Board of Adjustment

**Staff Report
BOA-23914**

PLAN CORRECTIONS SUMMARY

BLDR-211736-2025 (1804 N DELAWARE AVE E Tulsa Tulsa, OK 74110) Markup Summary #1

SITE PLAN

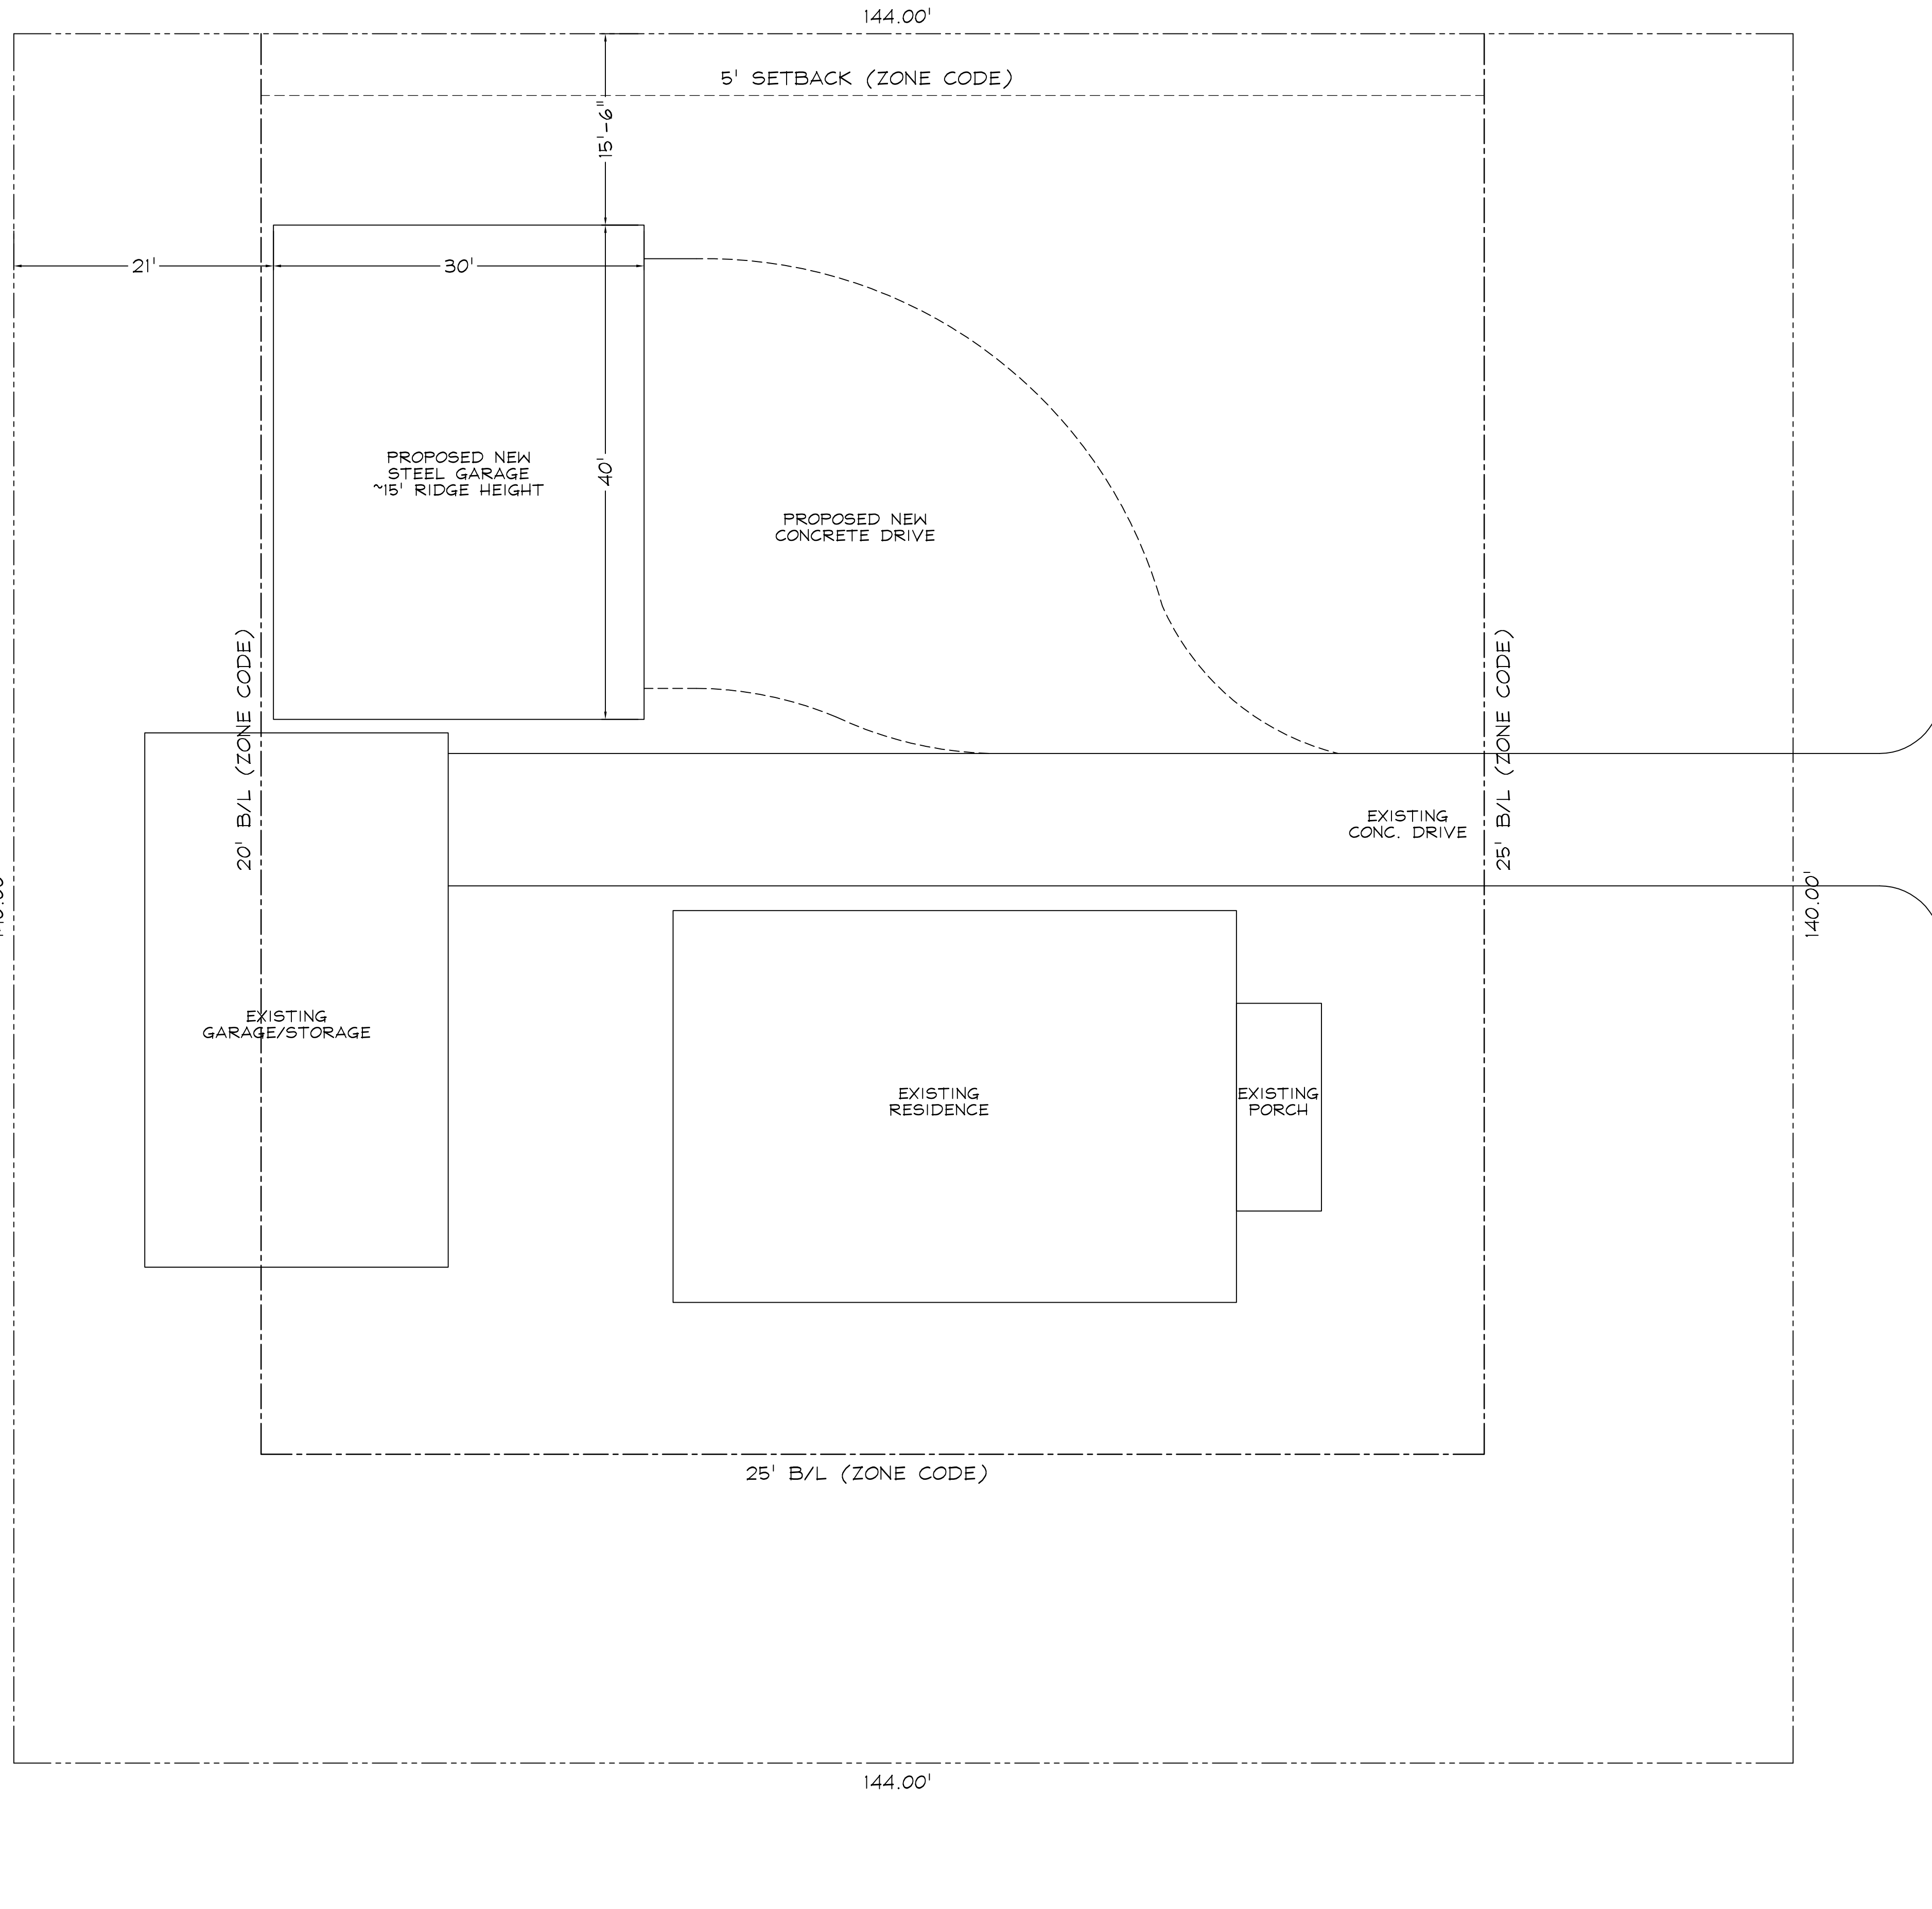
Two of these items were unresolved from the first review:
REVIEW COMMENT: Your application did not include a complete site plan. The zoning review for your permit application will resume after a complete site plan is submitted. Please note that additional deficiencies are likely to be found and will need to be resolved prior to approval of your application. Please add to or revise your site plan as necessary to provide these items:
· Drawing to scale showing the width of both of the existing driveways.
· A dustless all weather surface driveway is required. Gravel is not considered dustless all weather and is not allowed for new driveways. Revise the site plan to show a driveway to the garage, with driveway dimensions, and show the driveway material. The driveway material must be of a dustless all weather surface such as concrete or asphalt. You will need to show the driveway as it will be installed, for instance, it needs to serve both garage doors.

REVIEW COMMENT: You are proposing a combined floor area of 2,256 square feet of detached accessory structures. The proposed plus existing detached structures exceed 500 square feet and 40% of the size of the house. Based on the size of your house you are allowed 674 square feet of combined detached accessory structure floor area on your lot. As proposed, you have already exceeded the amount of accessory building area allowed for this RS-3 zoned lot.
